DEPARTMENT OF TRANSPORTATION  
STATE OF GEORGIA

**SUBJECT** APPROVED PROJECT CONCEPT REPORT

PROJECT CONCEPT REPORT

SR 282 from US 411/SR 61 East to CR 309

SR 282 AT CSX BRIDGE  
NO SCALE

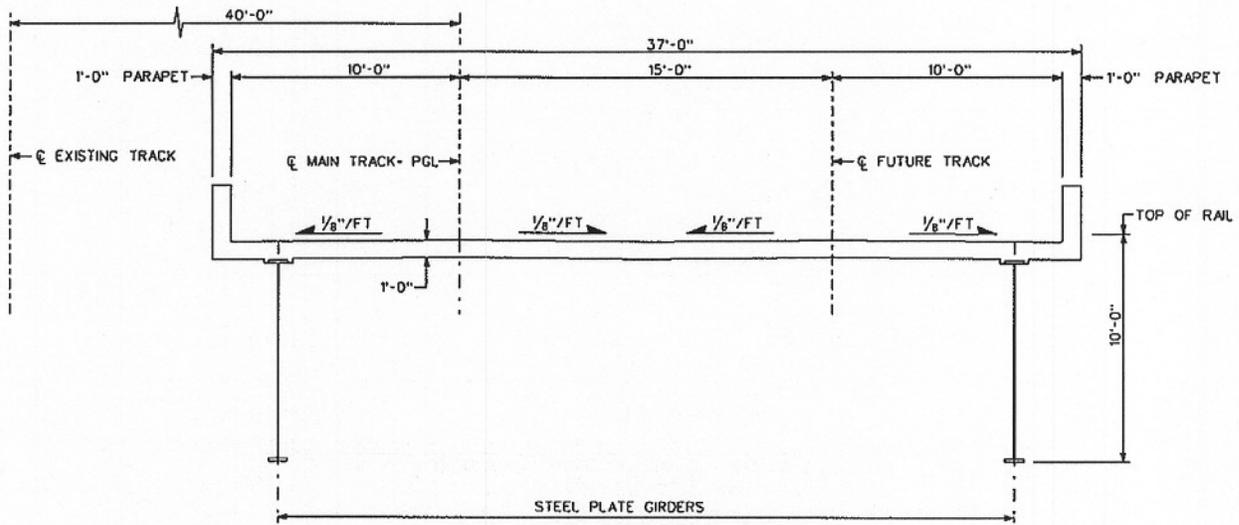
2) The Bridge for the RR has a hard cross slope to construct; please address during design
